# MD330U(I) Release note

Product : MD330U/MD330UI

Model Name Report : AVer MD330U , AVer MD330UI

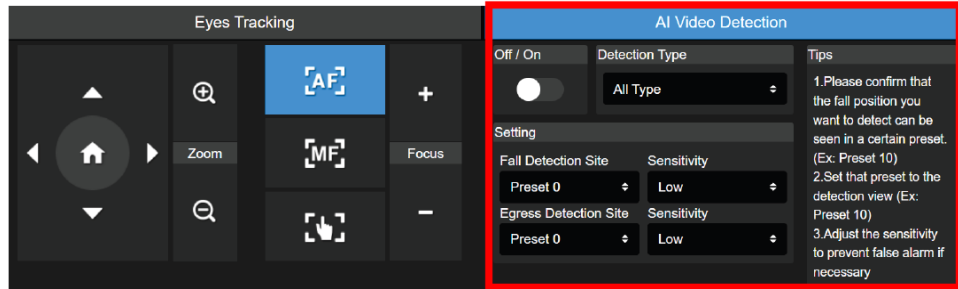
<b>FW version</b>	<b>1.1.1049.0</b>																						
Release date	2024/10/14																						
Checksum	1884d2ed070d35c8dedfc7fee8479790																						
New feature	<p><b>7. Support Zoom Mode</b></p> <p>If you are a Zoom Room user, please switch the mode of MD330U(I) to [Zoom Mode] Please note that MD330U(I) will automatically reboot after this action.</p> <p><b>How to change Mode</b></p> <table border="1"> <tr> <td><b>OSD</b></td> <td>[System]&gt;&gt;[ThemeMode]&gt;&gt; [AVer] or [Zoom]</td> </tr> <tr> <td><b>WEB UI</b></td> <td>[System]&gt;&gt;[ThemeMode]&gt;&gt; [AVer] or [Zoom]</td> </tr> </table> <p>**also support CGI/UVC-EXT , please contact tech support</p> <p><b>Behavior when mode change</b></p> <table border="1"> <thead> <tr> <th>Mode</th> <th>User Behavior</th> <th>Camera Behavior</th> </tr> </thead> <tbody> <tr> <td>AVer Mode</td> <td>Change to Zoom Mode</td> <td> <ul style="list-style-type: none"> <li>Reboot and become Zoom Mode</li> <li>IR Night Vision = [Auto]</li> <li>Sensitivity=[High]</li> </ul> </td> </tr> <tr> <td>Zoom Mode</td> <td>Load default</td> <td> <ul style="list-style-type: none"> <li>Load Zoom Mode default setting</li> <li>*overwrite current user setting</li> </ul> </td> </tr> </tbody> </table> <table border="1"> <thead> <tr> <th>Mode</th> <th>User Behavior</th> <th>Camera Behavior</th> </tr> </thead> <tbody> <tr> <td>Zoom Mode</td> <td>Change to AVer Mode</td> <td> <ul style="list-style-type: none"> <li>Reboot and become AVer Mode</li> <li>Keep current user setting</li> </ul> </td> </tr> <tr> <td>AVer Mode</td> <td>Load default</td> <td> <ul style="list-style-type: none"> <li>Load AVer Mode default setting</li> <li>*overwrite current setting</li> </ul> </td> </tr> </tbody> </table>	<b>OSD</b>	[System]>>[ThemeMode]>> [AVer] or [Zoom]	<b>WEB UI</b>	[System]>>[ThemeMode]>> [AVer] or [Zoom]	Mode	User Behavior	Camera Behavior	AVer Mode	Change to Zoom Mode	<ul style="list-style-type: none"> <li>Reboot and become Zoom Mode</li> <li>IR Night Vision = [Auto]</li> <li>Sensitivity=[High]</li> </ul>	Zoom Mode	Load default	<ul style="list-style-type: none"> <li>Load Zoom Mode default setting</li> <li>*overwrite current user setting</li> </ul>	Mode	User Behavior	Camera Behavior	Zoom Mode	Change to AVer Mode	<ul style="list-style-type: none"> <li>Reboot and become AVer Mode</li> <li>Keep current user setting</li> </ul>	AVer Mode	Load default	<ul style="list-style-type: none"> <li>Load AVer Mode default setting</li> <li>*overwrite current setting</li> </ul>

<b>OSD</b>	[System]>>[ThemeMode]>> [AVer] or [Zoom]																						
<b>WEB UI</b>	[System]>>[ThemeMode]>> [AVer] or [Zoom]																						
Mode	User Behavior	Camera Behavior																					
AVer Mode	Change to Zoom Mode	<ul style="list-style-type: none"> <li>Reboot and become Zoom Mode</li> <li>IR Night Vision = [Auto]</li> <li>Sensitivity=[High]</li> </ul>																					
Zoom Mode	Load default	<ul style="list-style-type: none"> <li>Load Zoom Mode default setting</li> <li>*overwrite current user setting</li> </ul>																					
Mode	User Behavior	Camera Behavior																					
Zoom Mode	Change to AVer Mode	<ul style="list-style-type: none"> <li>Reboot and become AVer Mode</li> <li>Keep current user setting</li> </ul>																					
AVer Mode	Load default	<ul style="list-style-type: none"> <li>Load AVer Mode default setting</li> <li>*overwrite current setting</li> </ul>

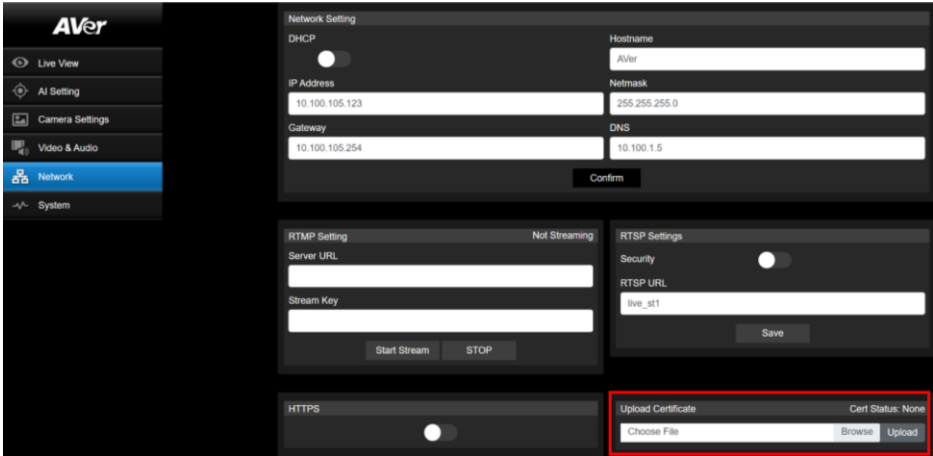
3. **Change default setting on IR Night Vision to be [Auto] [Sensitivity : Middle]**  
since this change , the [image process] would be set on [AWB] in default

WebUI >> System >> Camera Selector

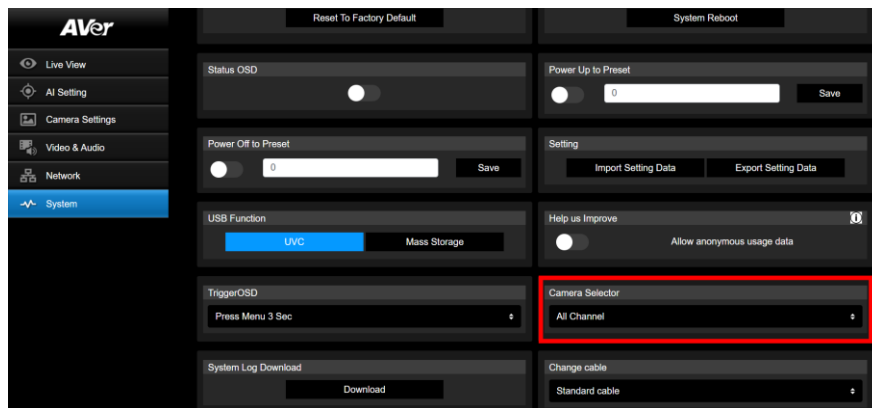
3. **Support PELCO-D & PELCO-P Camera Control Protocol (RS-232)**
4. **Now you can set the camera RC channel on WEB UI**

WebUI >> System >> Setting >> Import Setting Data

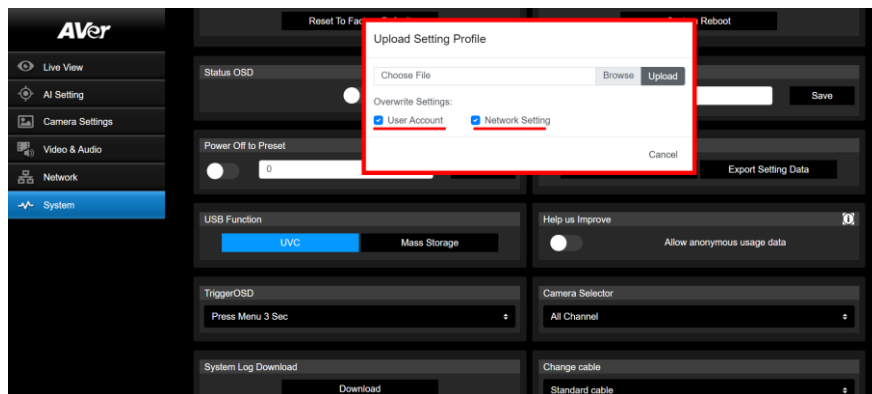
5. **Support more options to overwrite the setting when Importing Setting Data**

Check the [User Account] , [Network Setting] if you want to overwrite

### 3. Optimize user flow when download log

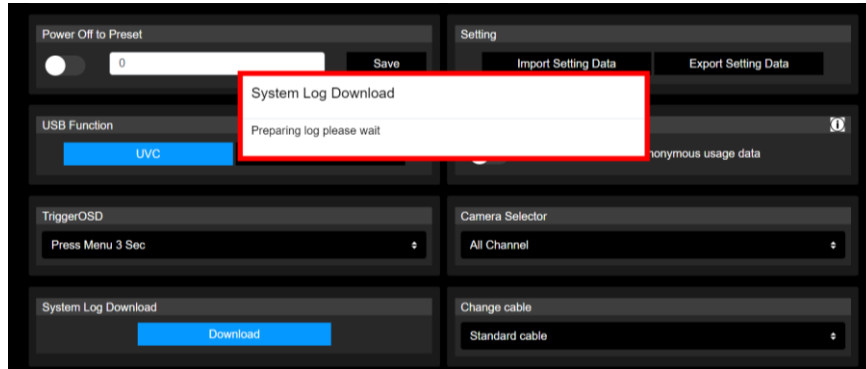
A prompt window will pop up when the UI is temporarily frozen due to downloading logs.

**2. Beep when snapshot is successful**

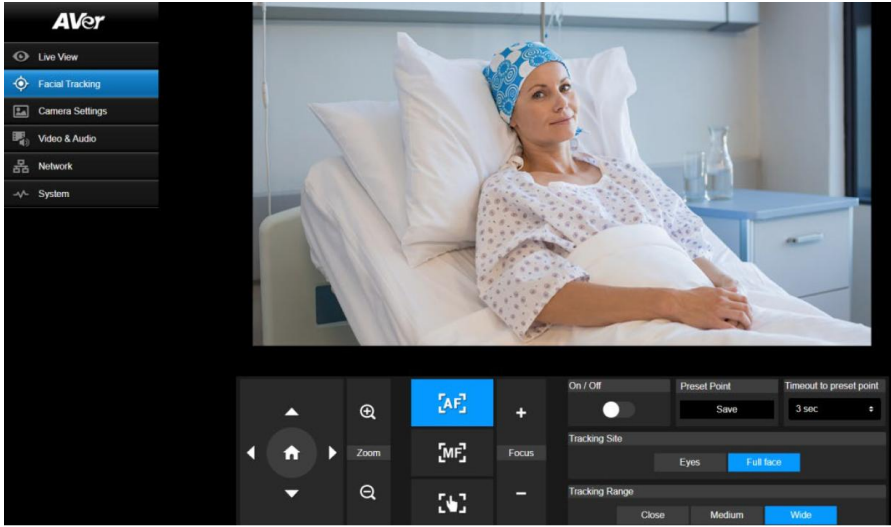
would trigger a beep on device speaker when the snapshot is successful
